Technical Service Bulletin

Technical Service Bulletin: tsb101677

Released Date: 13-Jul-2005

New Straight Thread Plug

17900065

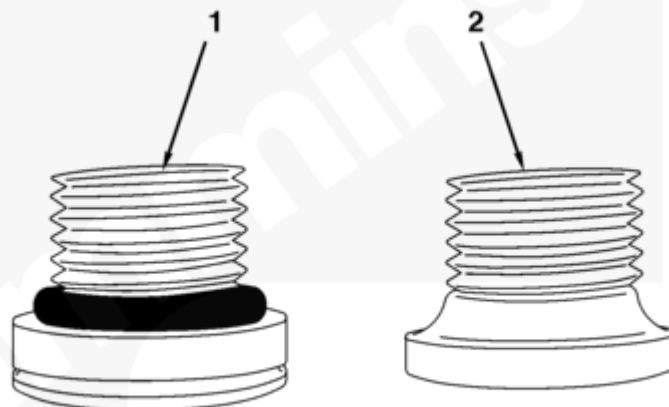
The new straight thread plug (2) has a pre-applied sealant. The previous straight thread plug (1) had a removable/replaceable o-ring.

The two plugs are interchangeable and reusable. The **only** difference between them is the installation torque value.

Both styles of plugs, and o-rings for straight thread plugs with o-rings, are available for service. Either plug can be used when a replacement plug is needed. The correct installation torque **must** be used.

The straight thread plug with pre-applied sealant can be reinstalled until the pre-applied sealant becomes damaged. Once damaged, the plug **must** be replaced. New sealant can **not** be applied.
